Magpie Composite Textile Ltd. (Extension)

28 May 2023

Observation

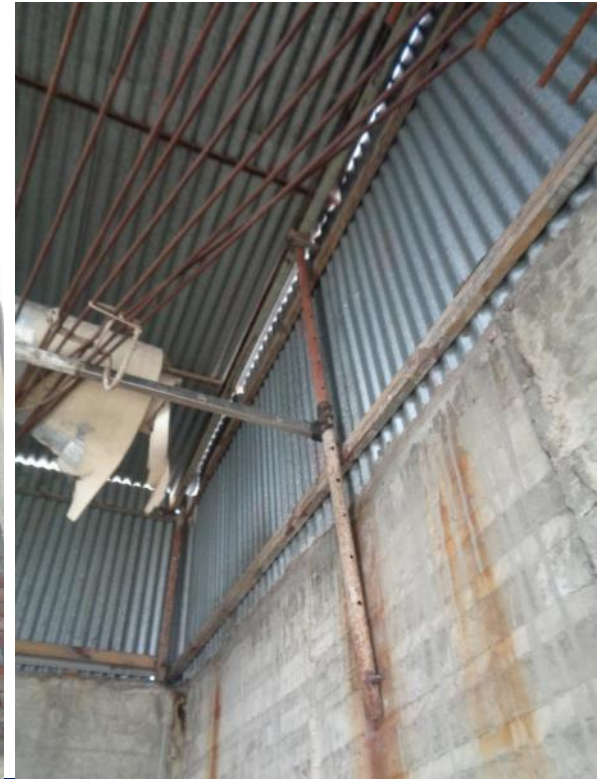
Exposed rebar prone to accident

Exposed rebar and very low clear height to stair which may cause accident

The building engineer is required to provide fall protection (barrier/railing) to avoid falling hazard from roof and stair.

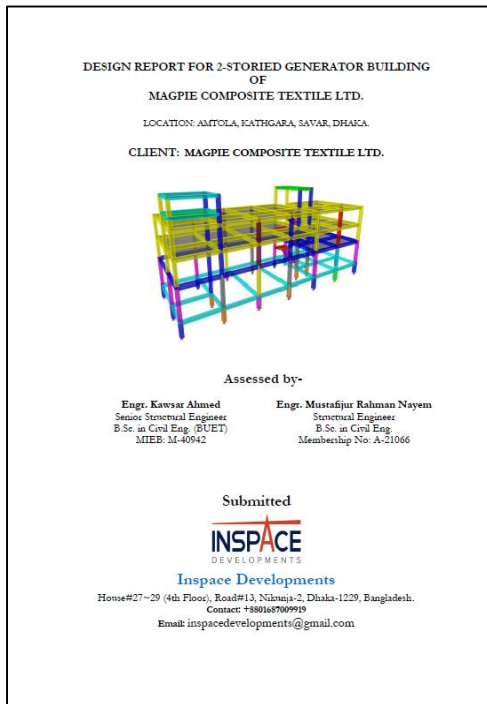
Trolley impact on columns and walls

Sign of trolley impact on column and wall

The building engineer is required to provide adequate protection/barrier for the columns & walls.
